**Northrop JN: 222337**

**Re: Calala BESS: SSD 52786213**  
 Response to submission regarding Water Management

This response represents an Addendum to the previously submitted report by Northrop titled: *Water Management Plan: Calala Battery Energy Storage System (Rev C, dated 24.07.23)*

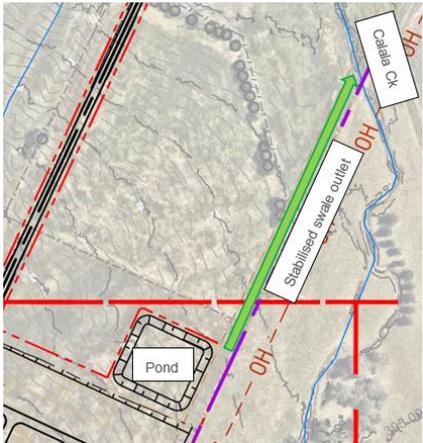
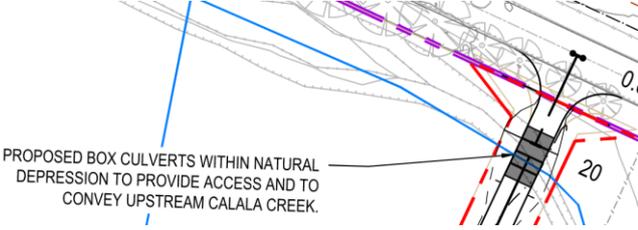
Submission comment		Response
<p><b>3. Stormwater Management</b></p> <p>The site management consists of collection and conveyance systems directing runoff to a proposed wet basin. The stated objectives are to capture sediment from unsealed areas (during the establishment, operation and decommissioning phases), and to trap pollutants from battery cells in the event of a fire. The nominated water management plan should be updated to require:</p>	<p>The treatment of potentially turbid water generated by the unsealed access track, which is located downstream of the proposed wet basin. Sediment basins could be incorporated upstream of the interface with Calala Creek.</p>	<p>The road approach to Calala Creek is on very flat land where runoff will tend to pool and flow slowly, thereby allowing sediment to settle on the farm paddocks. Therefore, sediment basins are considered to be superfluous in this situation. However, if treatment is required, this may be resolved subject to approval conditions.</p>

<p>Definition of the overflow channel alignment from the proposed basin, including details of the discharge arrangement to Calala Creek.</p>	<p>The overflow channel will be a vegetated swale that discharges into Calala Creek, as shown indicatively over.</p> <p>The discharge arrangement will comprise a rip-rap outlet to blend in with the banks and bed of Calala Creek.</p>

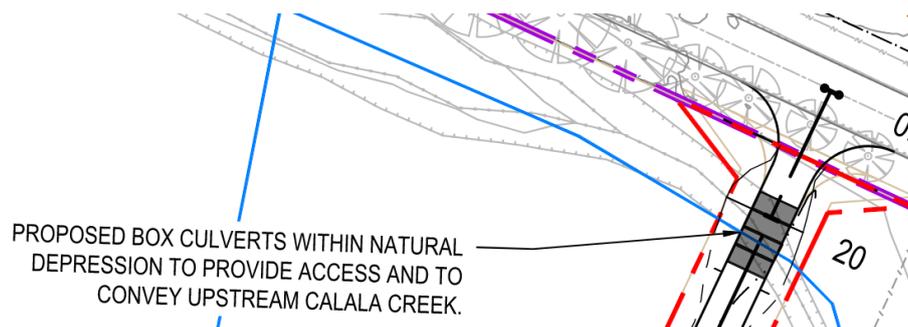
1. The stabilised swale outlet from the proposed sediment pond/wet basin will flow through the riparian zone into Calala Creek (this was not shown on the Drawings provided in the EIS submission, but is shown indicatively below)

The **assessment of the proposed outlet structure** in relation to the Guidelines follows:

- Point of discharge is stable (although modified)
- Construction footprint is minimal
- The discharge structure is rip-rap blending in with the banks and bed of the creek

- No noticeable changes to hydrology or hydraulics will occur. No bed or bank erosion is expected to occur
- The discharge structure shall be oriented to discharge at an angle to the flow (not perpendicular)

- Detailed Design to consider tractive forces for rock sizing. It is anticipated that 100-250mm rip-rap rock diameter will be suitable
- Disturbed areas adjoining the works will be stabilised with soil, mulch and plantings of grass and sedges

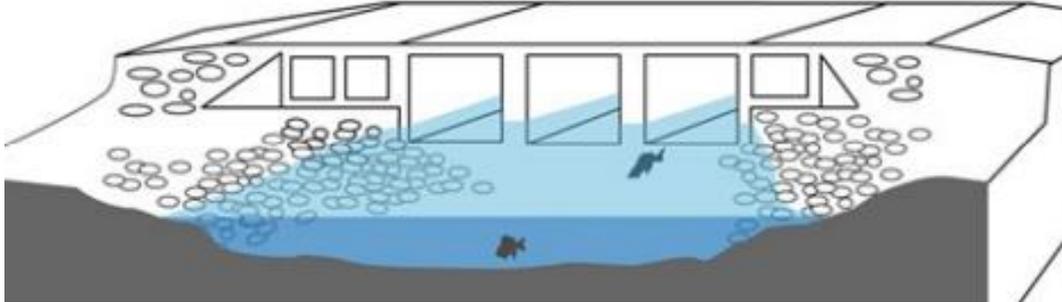
In these locations, Calala Creek has been heavily modified by past agricultural activity, including cultivation, which has altered the bed and bank features compared to nearby reaches of the creek where this has not occurred. The creek is ephemeral, flowing only after significant rainfall in the catchment. When not flowing, the creek channel is a wide grass-vegetated swale with no other features distinguishing it as a creek, as shown over:

The **assessment of the proposed watercourse crossing** in relation to the Guidelines follows:

- The selection of a box culvert crossing over the creek is consistent with the Guideline
- The culverts will be installed to be flush with the bed level of the creek – thereby allowing fish passage
- Culverts shall be aligned with direction of flow
- Detailed design may incorporate elevated dry culvert cells in combination with wet cells, as indicated below

- Detailed design to include: survey, cross sections, long section, bed and bank profiles
- Hydraulic assessment and calculations to size the culverts
- Associated bed and bank stabilisation works for scour protection to be shown
- Vegetation plantings shall be grasses and sedges – to be designed
- Erosion and sediment control plan to be included. Erosion and sediment controls will be placed downstream of the works during and immediately after construction, i.e. a sediment fence and straw bales
- Works shall occur in a dry period – noting weather forecasting for 3-4 weeks. If rain >1mm is forecast, works should be delayed.
- A maintenance period of 3 years shall apply
